TOWN OF UNDERHILL

Development Review Board

JASON A. & KAREN M. GUYMON AND
ANTOINE M. & PAMELA J. CATUDAL
PRELIMINARY & FINAL SUBDIVISION REVIEW
Docket #: DRB-19-08

Applicant(s): Jason A. & Karen M. Guymon and Antoine M. & Pamela J. Catudal
Consultant(s): Rob Goodwin (Surveyor) & Michael Gervis (Engineer)
Property Location: 73 North Underhill Station Road (NU073)
Acreage: ±29.9 Acres
Zoning District(s): Rural Residential

SECTION 3.18 – STEEP SLOPES

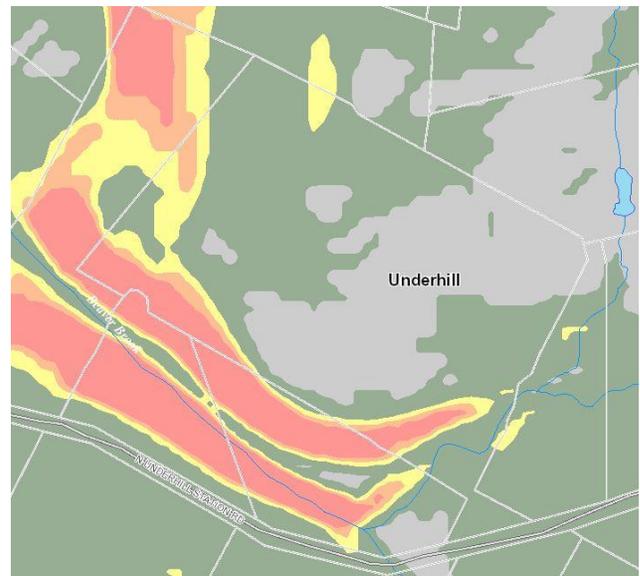
- Areas of steep slopes (15-25%) are present on the existing lot (see directly to the right).
 - Steep Slopes (15-25%) and Very Steep Slopes (>25%) appear to affect both lots; however, the proposed/existing developments (single-family dwellings) appear to be outside of these areas.
- Since both driveways are already constructed, no significant additional impact to these areas is anticipated.
 - The Board should determine if additional review under this section is required, as the shared driveway will need to be widened to 14 ft.
 - If the Board finds that the widening of the driveway will occur on land that is under 15% slope, then no further review under this section is required.

SECTION 3.19 – SURFACE WATERS & WETLANDS

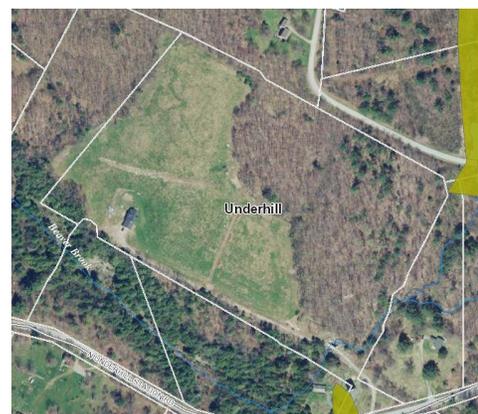
- An unnamed stream bisects the southern portion of the lot in an east to west direction (see directly to the right) – 25 ft. Setback Requirement.
- Beaver Brook is located to the south of the property; A 50 ft. Setback from the “top of slope” is required since no floodplains are associated with the Brook in this location.
- A Class II Wetland has been identified to the northeast of the property, as well in the south portion of the property – 50 ft. Setback Requirement.
- All anticipated new development is expected to satisfy the aforementioned setback requirements for wetlands and surface waters.

SECTION 8.2.C – EXISTING SITE CONDITIONS PG. 151

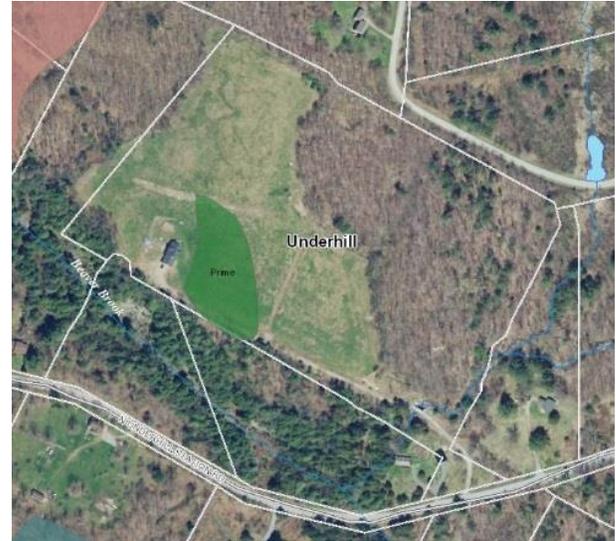
- A small area of prime agricultural soils will likely be bisected by the proposed property line (see directly right in comparison to Exhibit H); anticipated development could potentially impact this area.

- Given the proposed location of the single-family dwelling on Lot 2, as well as the completed single-family dwelling on Lot 1, and the completed driveways, the prime agricultural soils seem to be the only resource being impacting:

- The Board could explore if there are any options for minimizing impact to the prime agricultural soils.
- The proposed layout of the subdivision and development does not appear to adversely affect any of the other existing site features and/or natural amenities listed in this subsection.
